NELSON CITY COUNCIL

**Nelson Resource Management Plan**

Proposed Plan Change 23  
Daylight and Solar Panels

**Proposed Plan Amendments**

FIGURE 5 DAYLIGHT AROUND DIAGRAM

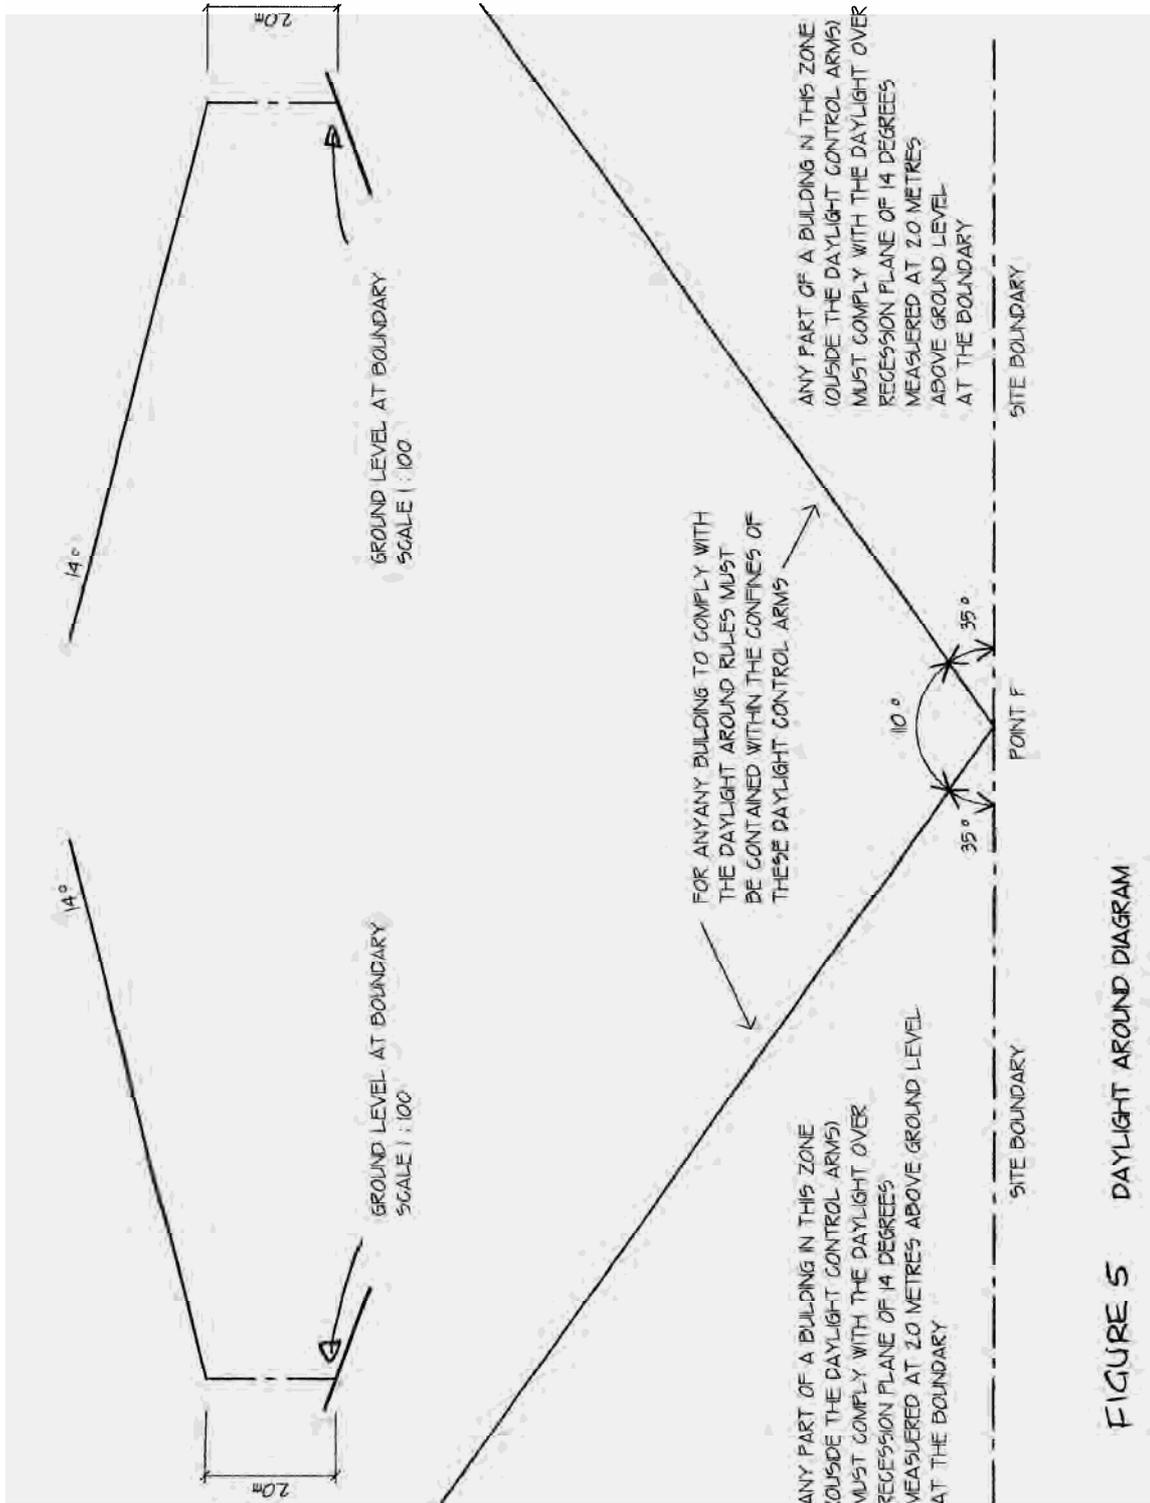
Figure 5 To improve clarity, Figure 5 has been replaced with two separate diagrams for daylight around (figure 5) and daylight over (figure 6).

*Replace Figure 5 (on page A15-8) with two separate diagrams for daylight around (figure 5) and daylight over (figure 6) as shown on the following two pages.*

- i) Apply the daylight around angle (Figure 5) as outlined in Ap15.9.i. To find out how high intrusions may be, start at 2m above ground level immediately adjacent to the point of consideration of the building. The maximum height then increases 0.5m for each 2m distance from the boundary. This is a recession plane of 14° inclined into the site, measured from a point 2m above ground level at all points along the relevant boundary.

FIGURE 6 DAYLIGHT OVER DIAGRAM

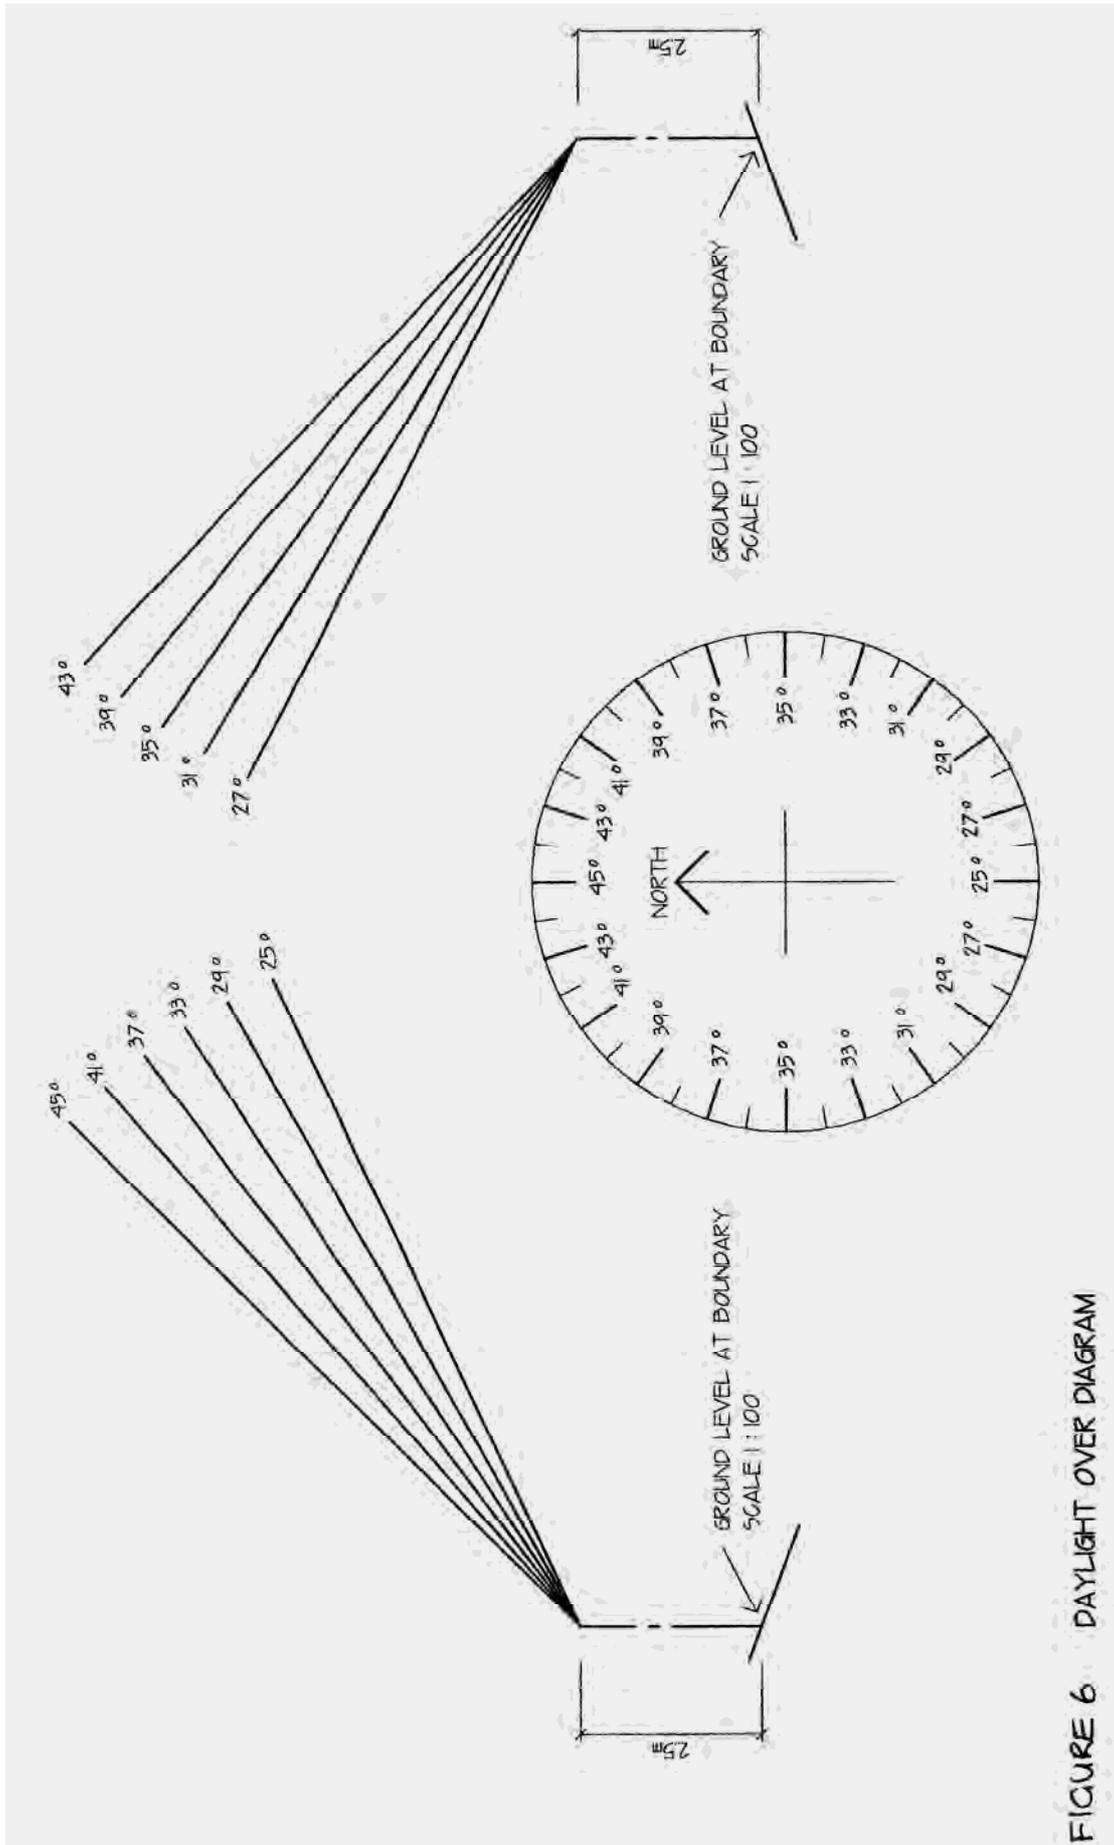
AP15.7 This change adds a reference to the new Figure 6 (daylight over diagram) and adds a note to Figure 1 on page A15-4 to provide further explanation of the reasons for the daylight controls.

AP15.7.i Make sure the central control arrow is pointing due North as shown in Figure 2. The angle where the indicator touches the boundary is the angle to be applied 2.5 m above ground level at the boundary. This is illustrated in Figure 3 and Figure 6.
